Service Bulletin

No. : MZ08-048

Model: ES7001

Subject: Change of OPT Connector

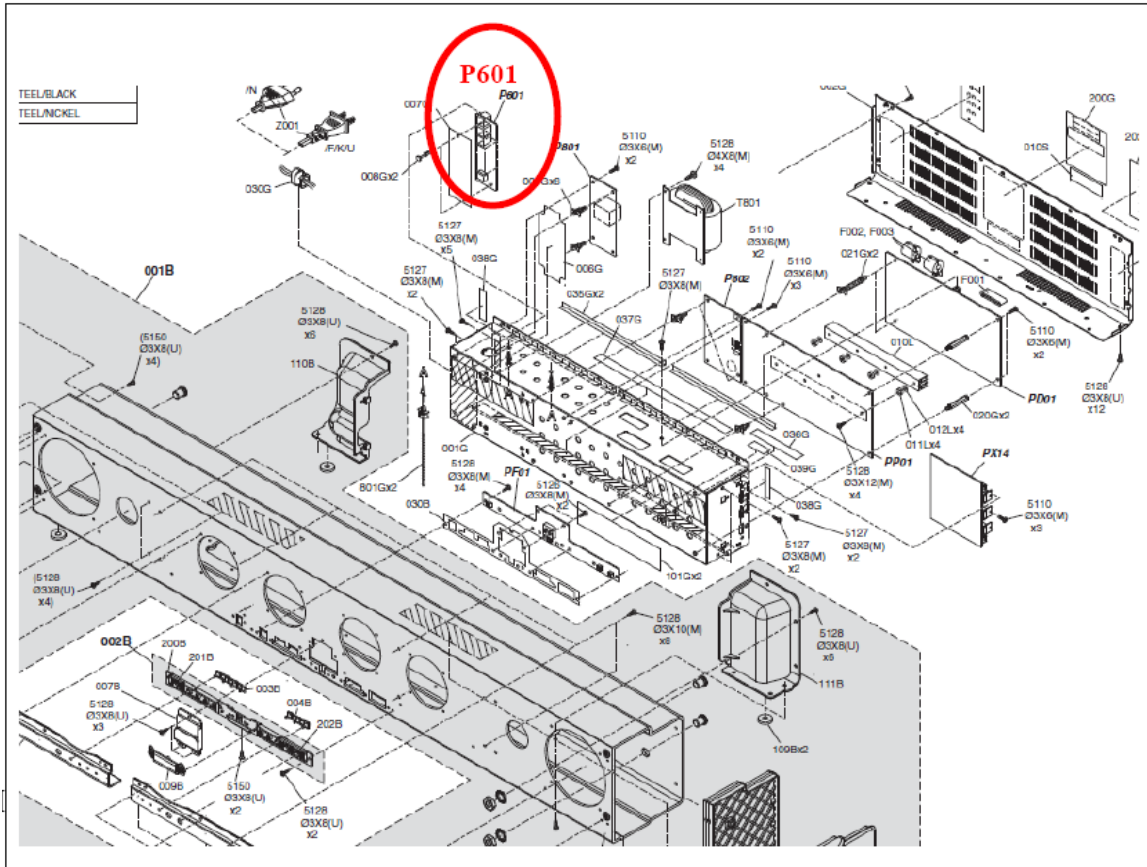
Symptom: The Optical connector shutter has been broken when the OPT cable is unplugged.

Solution: 1. To prevent the optical connector from being damaged, it has been replaced with one without a shutter. All three POS NO. JR01, JR02, JR03 (INPUT PWB P601) will be all replaced.

All the three to be replaced.

Old PART NO. 00MYJ15000270

New PART NO. 643010054005S
